RE: Limon Sand and Gravel Resource, DRMS File M-2024-053
112 Construction Materials Permit Application - Adequacy Response

The attached letter addresses each adequacy item in your January 30, 2025 letter regarding the Limon Sand and Gravel Resource 112 Permit Application. Feel free to contact me with any questions.

Figure 1 – Vicinity Map

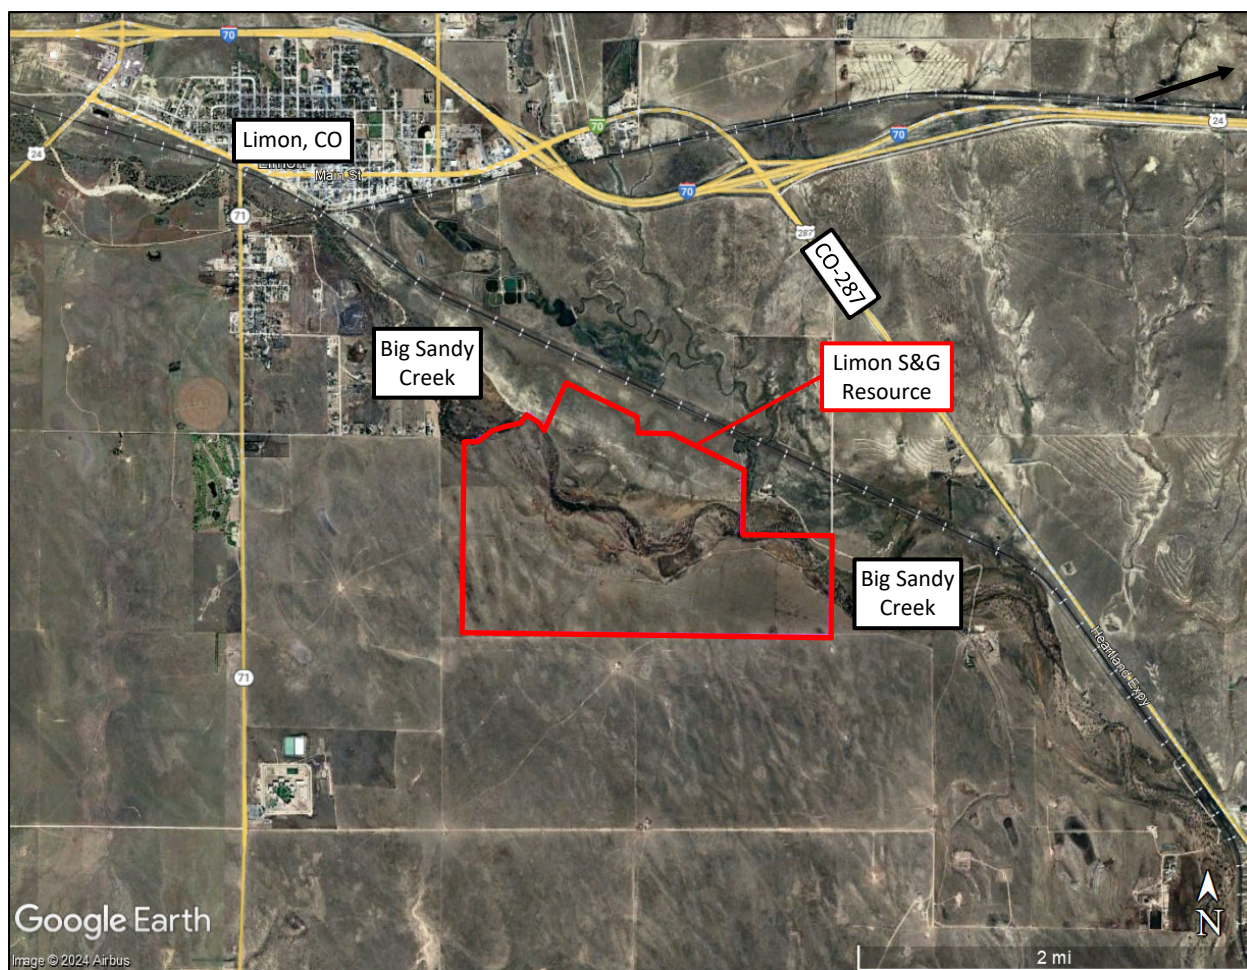
5. *Two maps are required within the GWMP. One map to show the vicinity of the proposed permit area and its geographic region. A second map to show the proposed monitoring well locations, the potentiometric contour lines of the existing water table or details about the groundwater directional flow, information on all permitted wells, all springs and seeps, and any geological*

Figure 1 depicts the proposed permit area and geographic region. A map was added to Appendix 1 that depicts the remaining items.

Figure 2 – Groundwater Sampling Locations

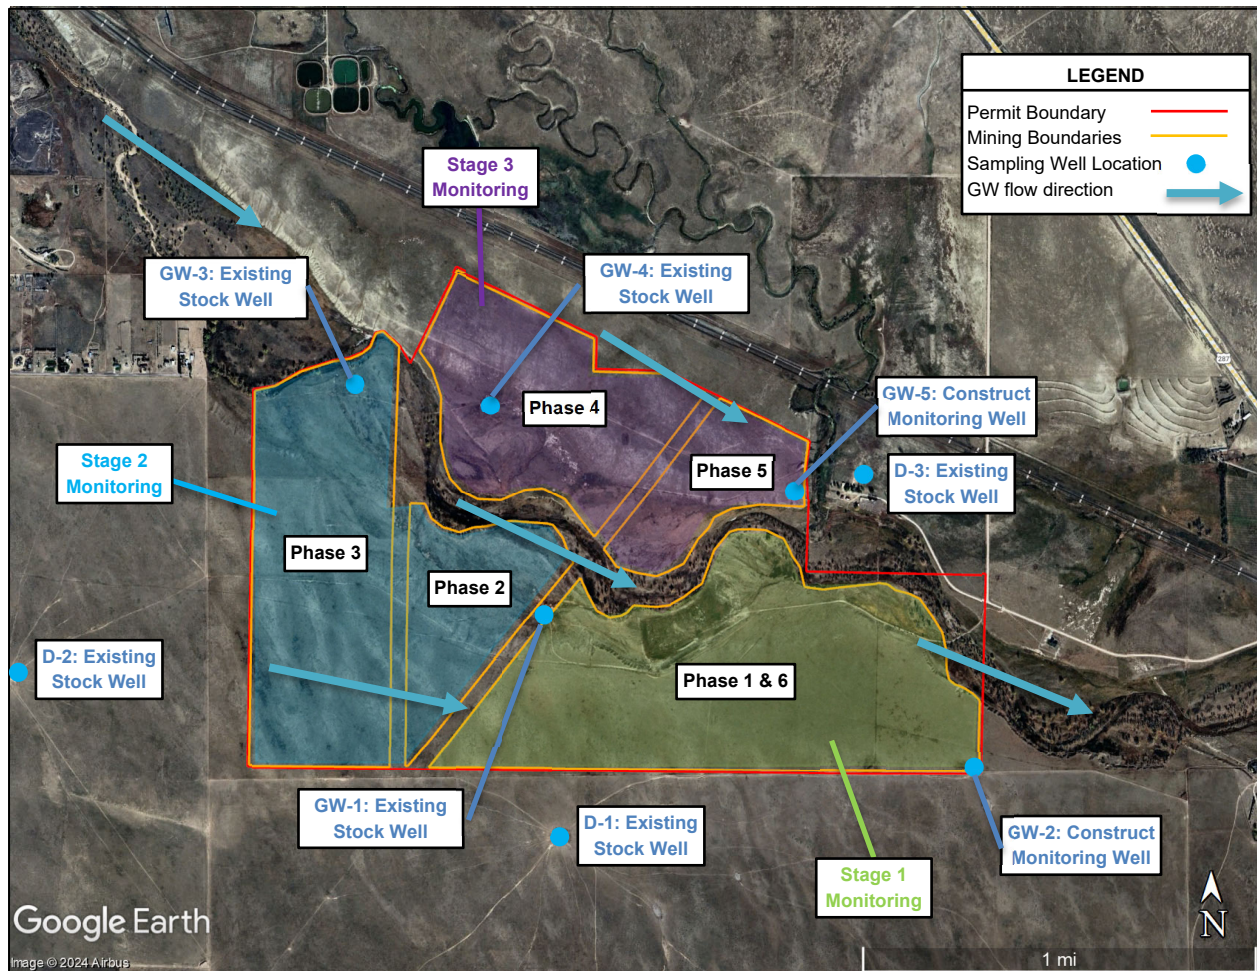
outcrops that may be present in the area. There is one arrow provided in Figure 2 – Groundwater Sampling Locations, however, one arrow describing the groundwater flow is not sufficient given the large size of the proposed permit area. The two images provided do not meet the requirements of a map as outlined by Rule 6.2.1(2) and the Guidance Document. Please provide two maps that meet the requirements outlined in Rule 6.2.1(2) (with the exception of the scale requirements) and that includes all of the required information given in item 1.1. Site Description of the Guidance Document.

Figure GS-1. Locations of Slope Stability Analysis from Map F-1

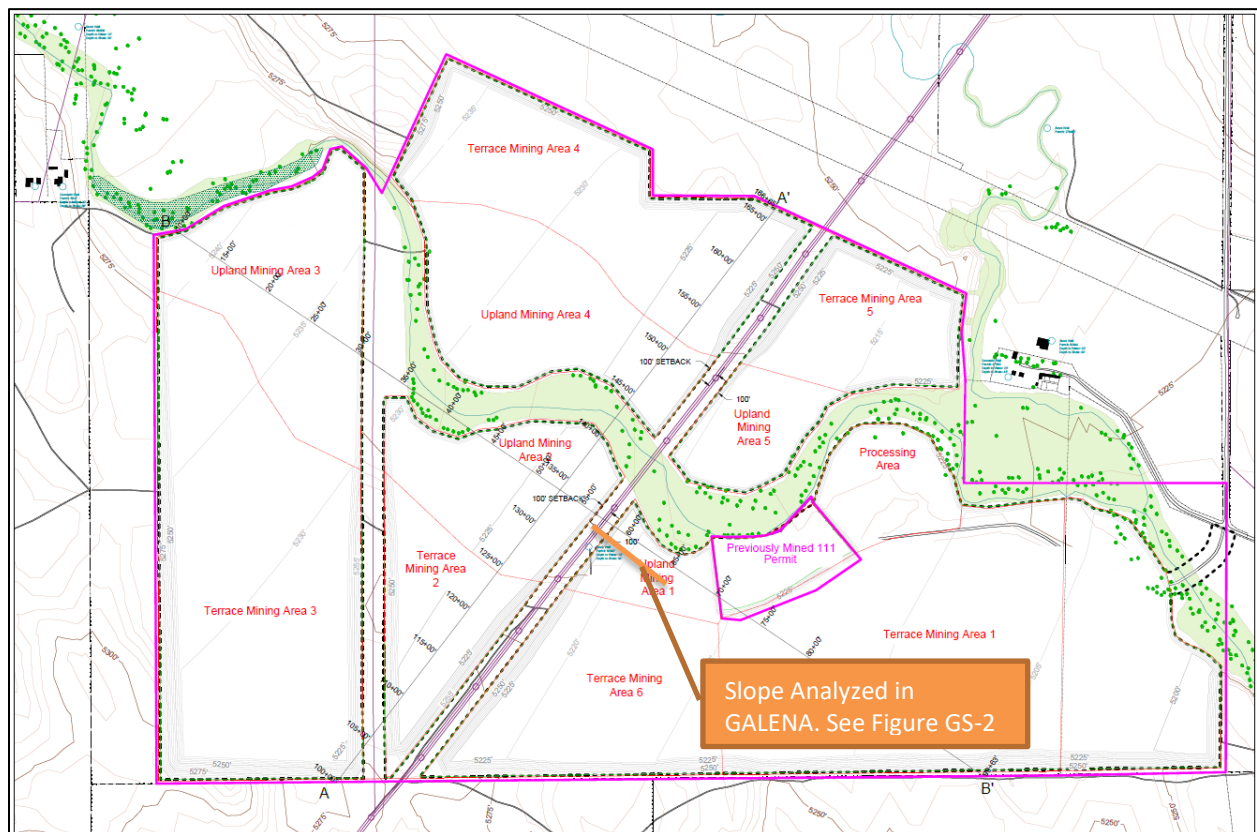
31. The intended mining setback is not clearly defined within the exhibit. On page GS-4 of the application, a setback of greater than 120 ft is listed for the active mining phase of the operation within table GS-2. An addition setback of 110 is listed with a FOS of 1.5. Later, a setback of 50 ft is mentioned based upon the location of a 1.5 FOS compared to the closest structure. Please clarify the total intended setback from the transmission lines.
